**AGENDA
FARRAGUT MUNICIPAL PLANNING COMMISSION**

**May 18, 2017
7:00 p.m. Farragut Town Hall**

SUBJECT: Discussion and public hearing on a site plan for the NHC Memory Care Facility at 120 Cavette Hill Lane, 15.504 Acres, Zoned C-1 (National Healthcare Corporation, Applicant)

**SUBJECT: STAFF COMMENTS ON THE SITE PLAN FOR THE NHC
MEMORY CARE FACILITY AT 120 CAVETTE HILL LANE**

LANDSCAPE PLAN
SCALE: 1"=30'

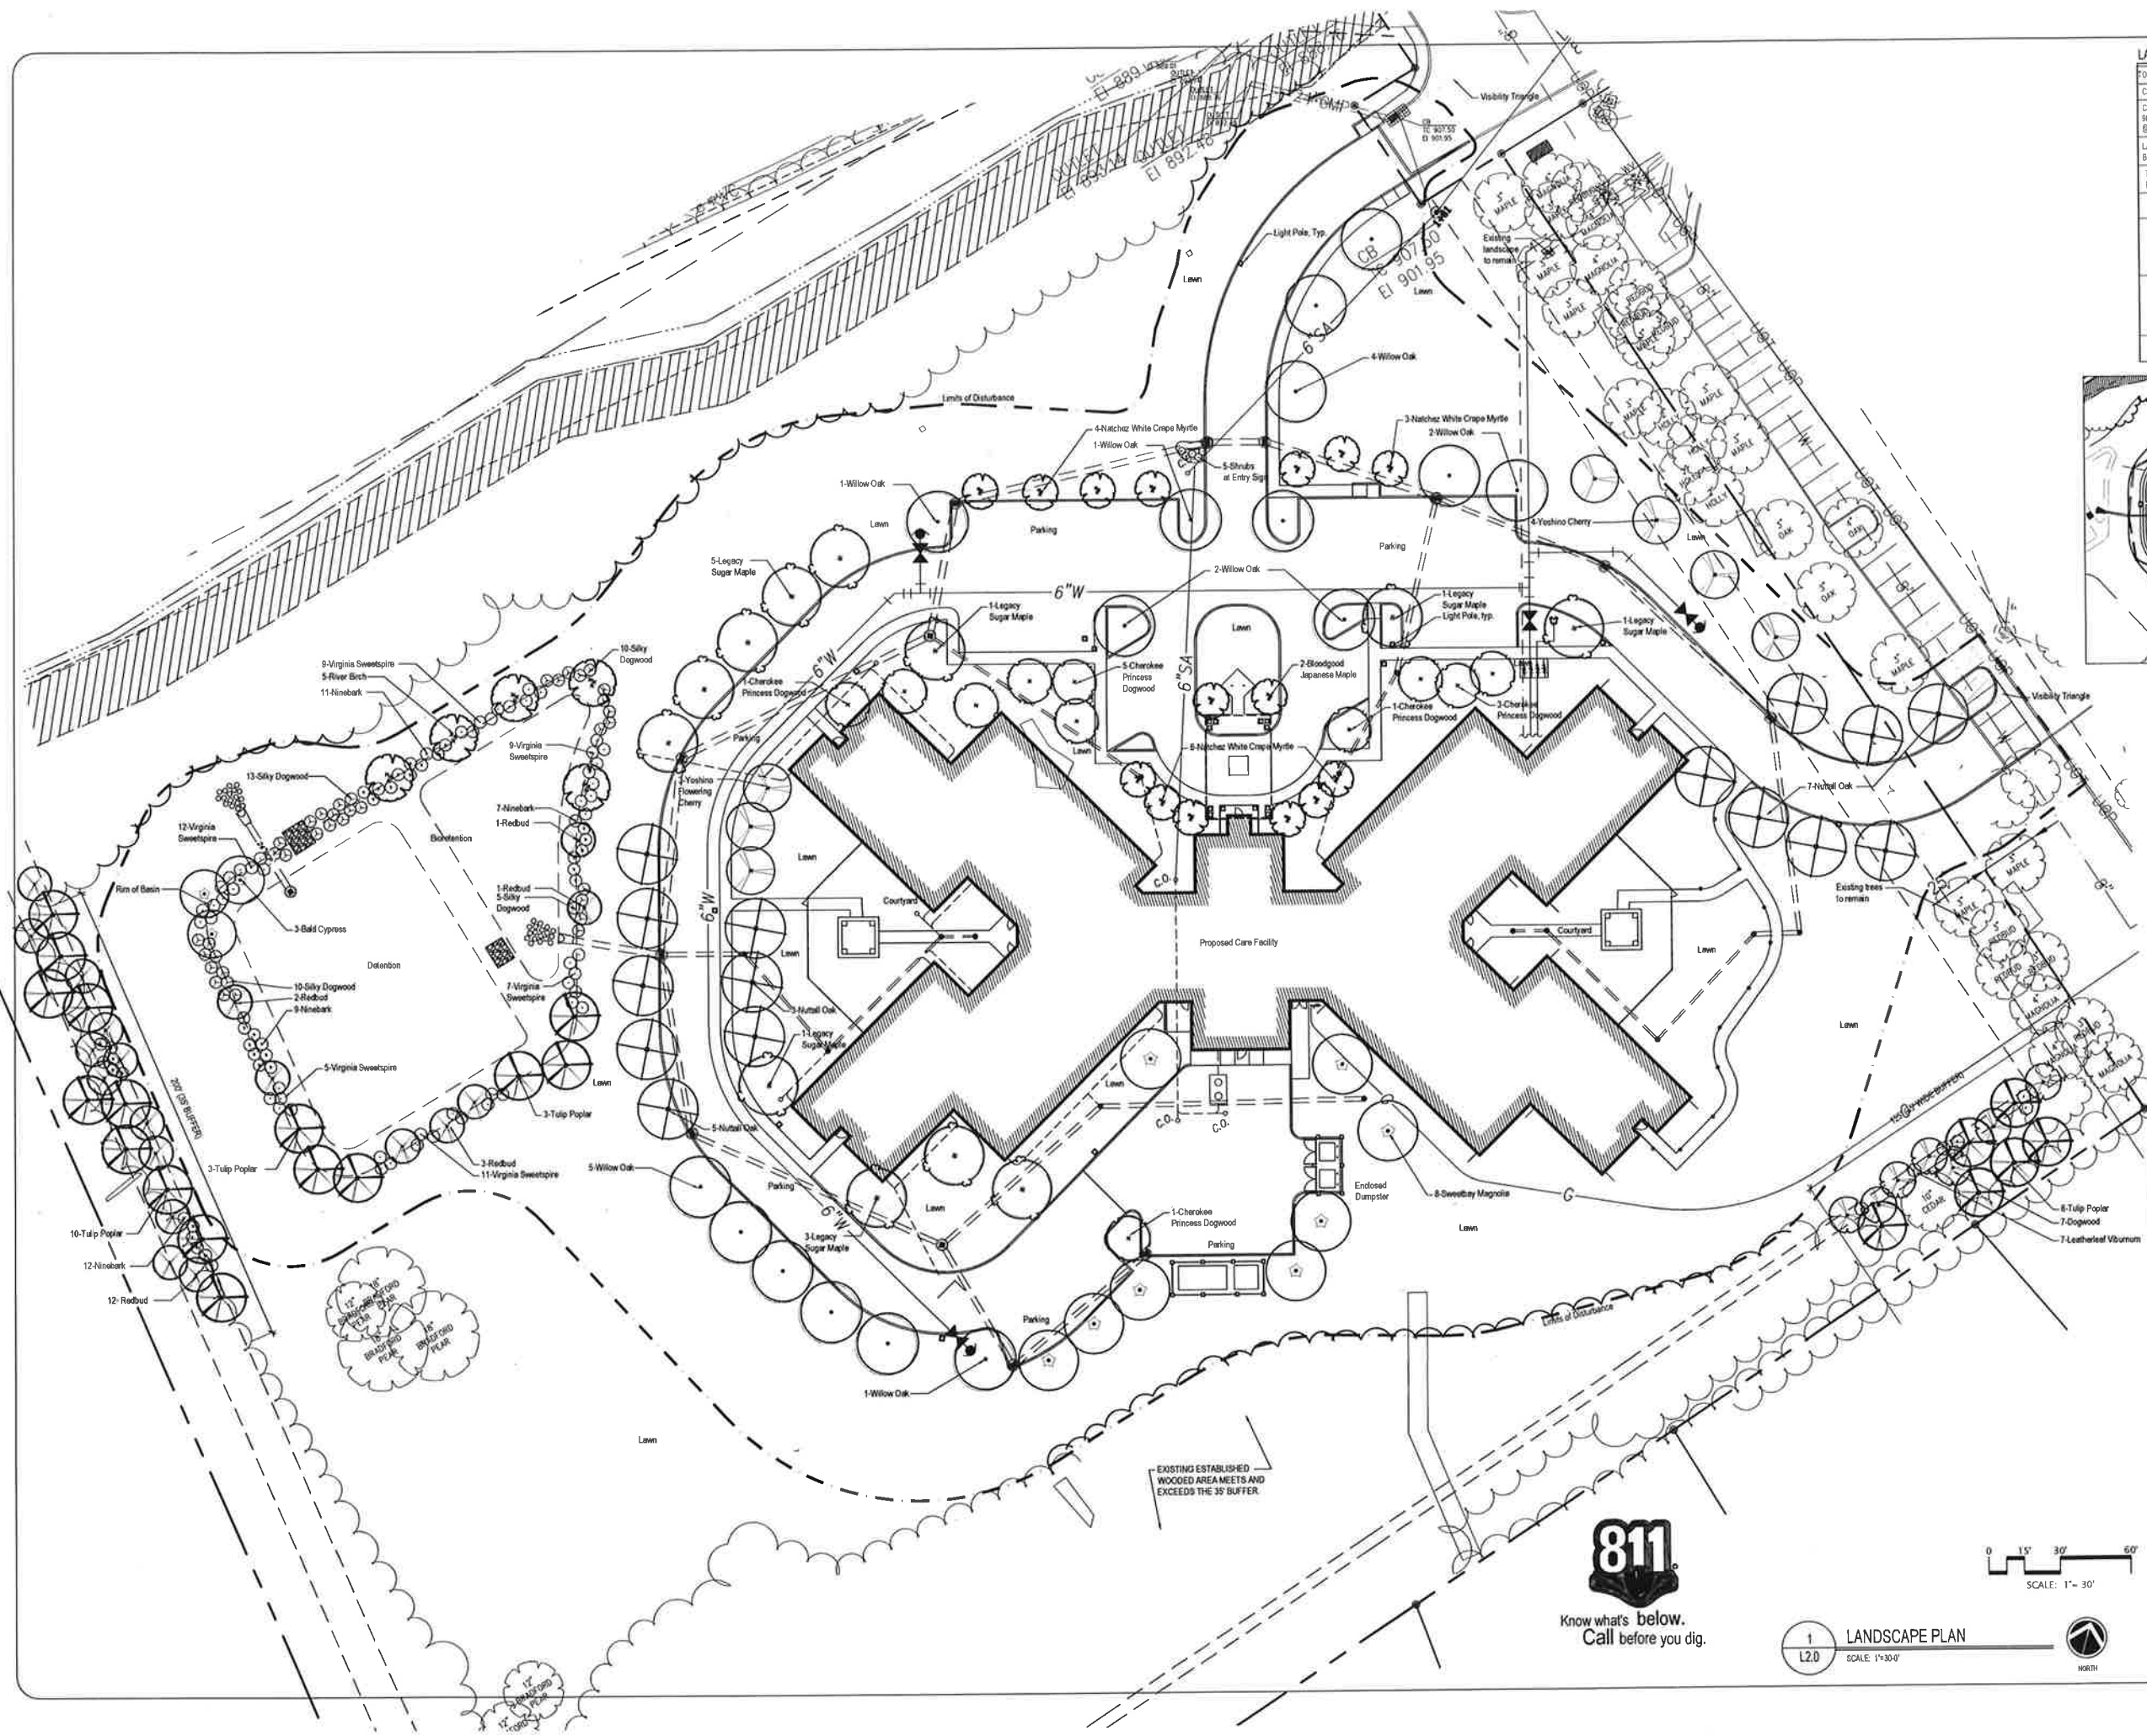
- 13) Please ensure that the landscape plan is consistent with the site plan. A landscape plan must be approved prior to the issuance of a grading or building permit;

Response: Landscape plan has been revised to match the latest revised site plan. A separate submittal will be made for the full landscape design and approval (June VRRB Meeting).

A6.4

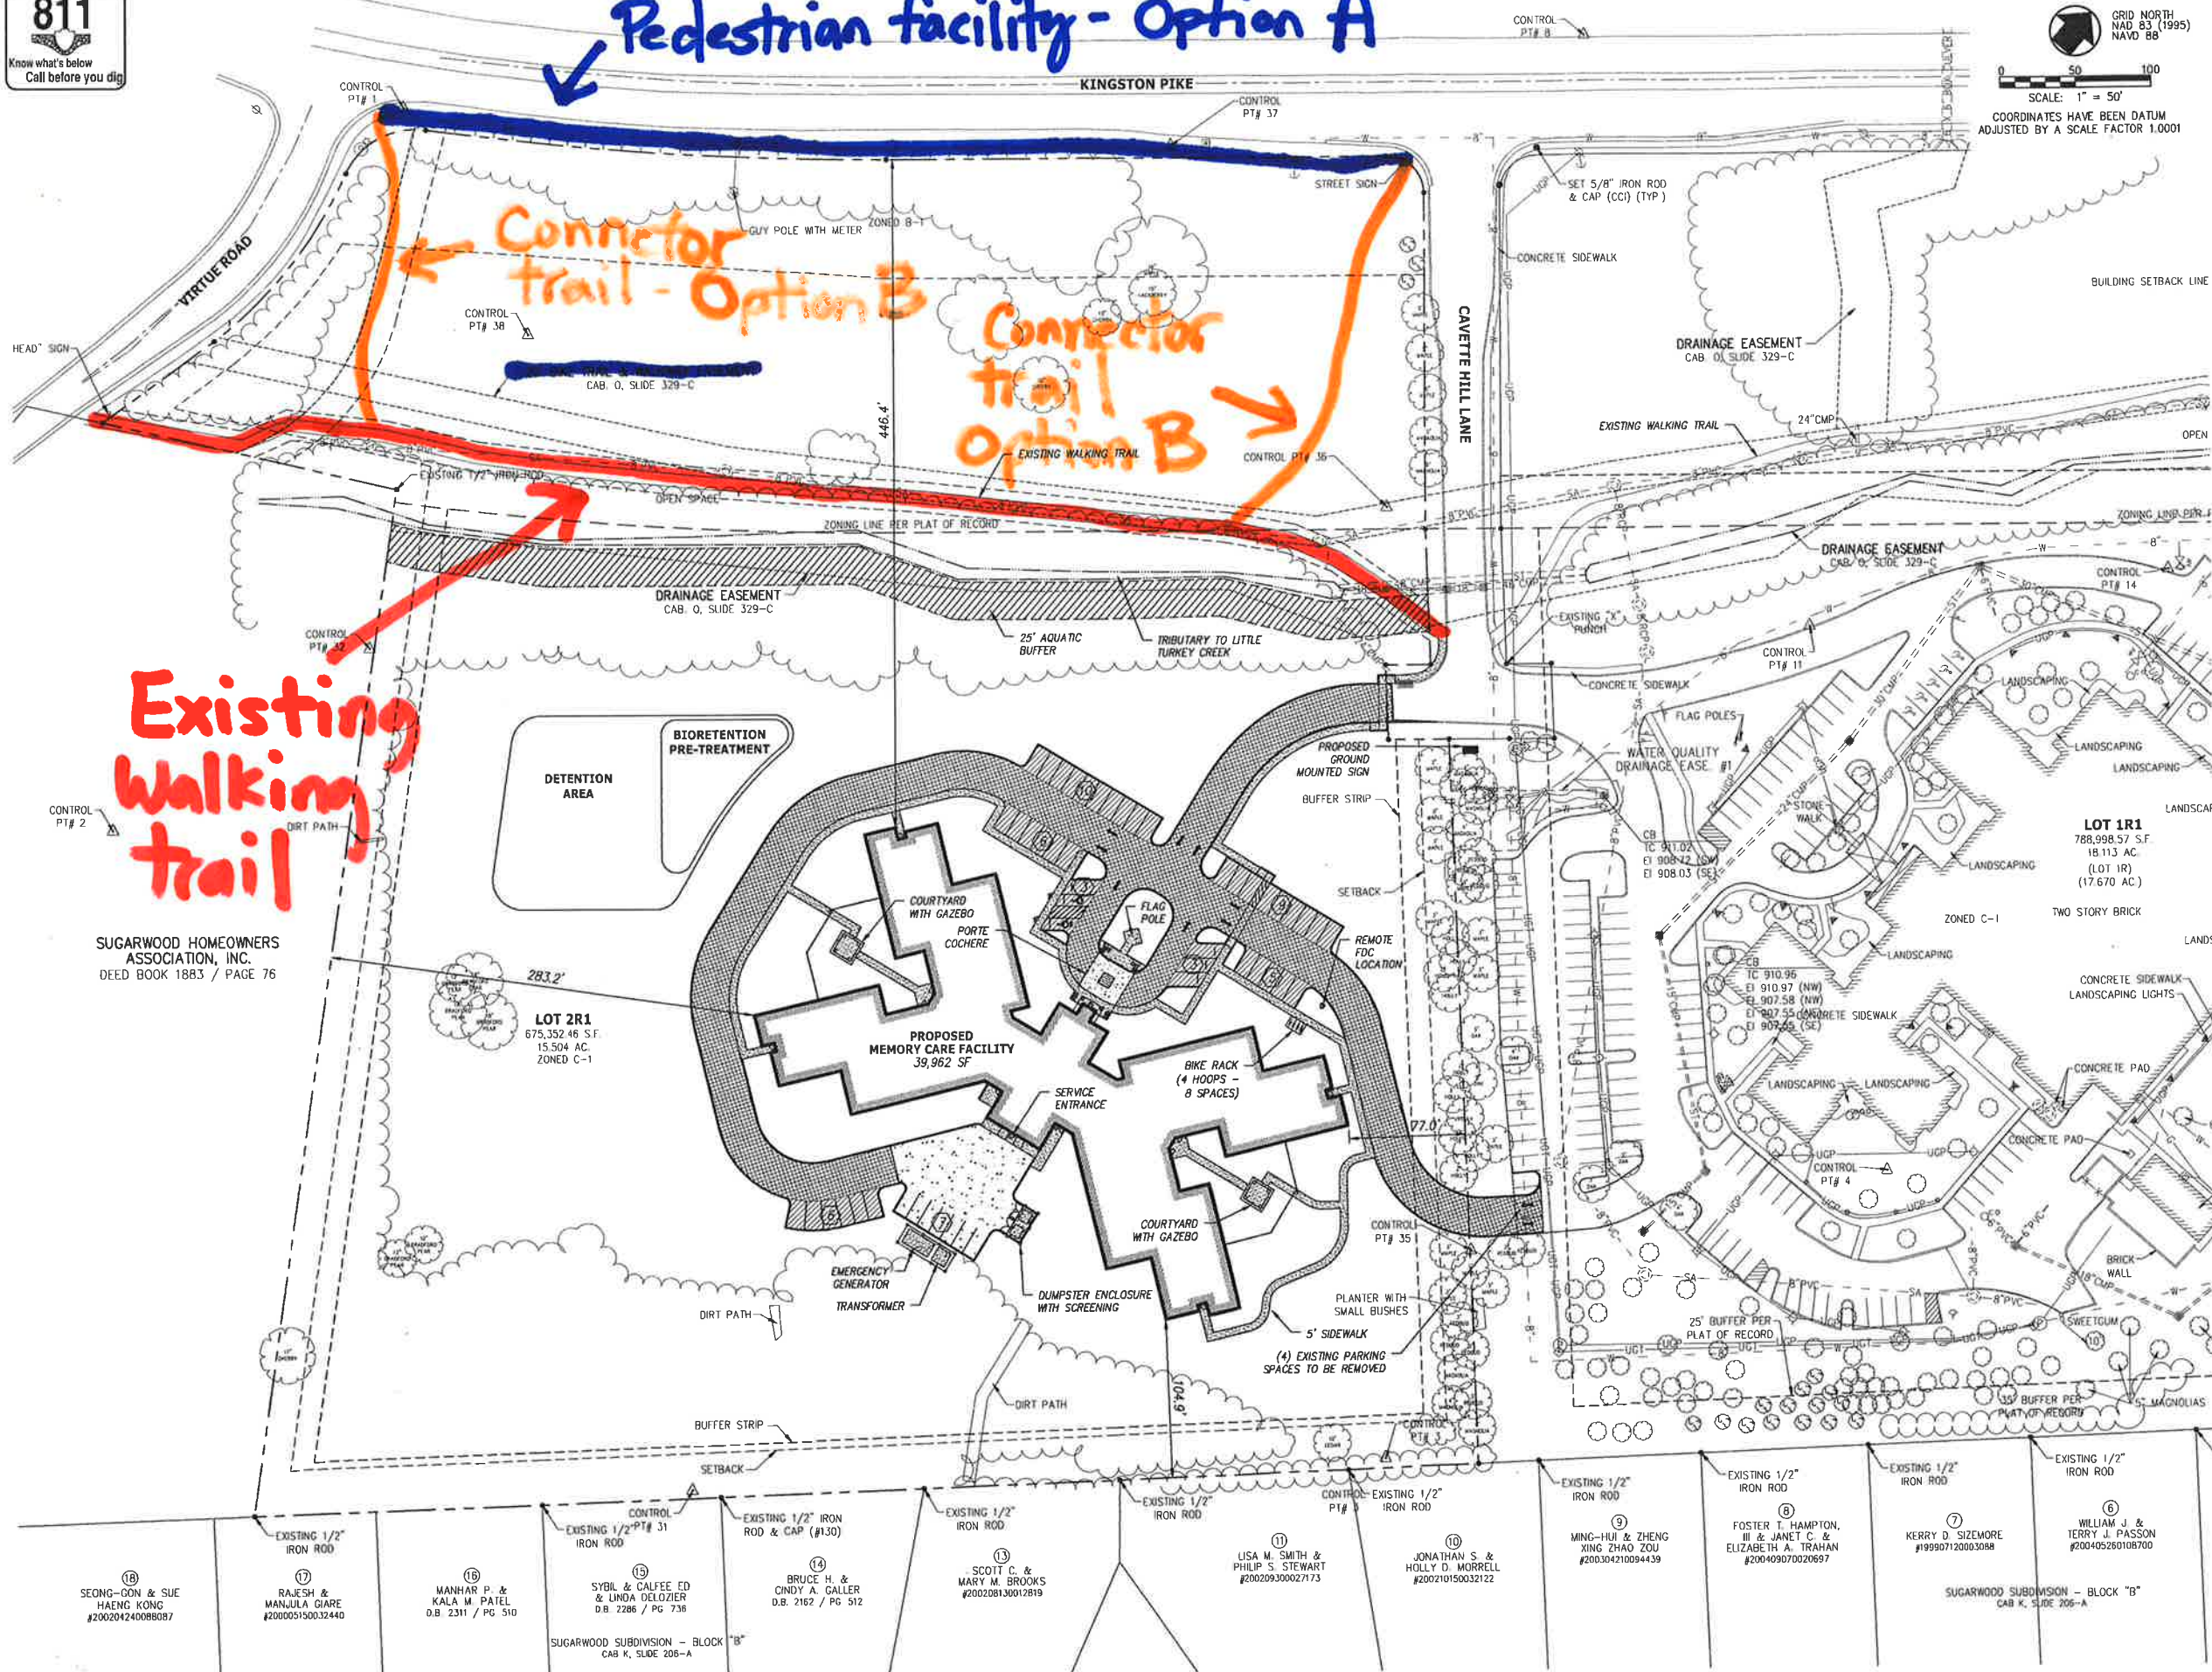
- 14) Please verify and note on the plans that the net façade area of the building will be at least 75% masonry (brick or stone). This is required in the ADS;

Response: Tables were included in the previous submittal on A6.4 showing the percentage of brick for the building (76.52%).
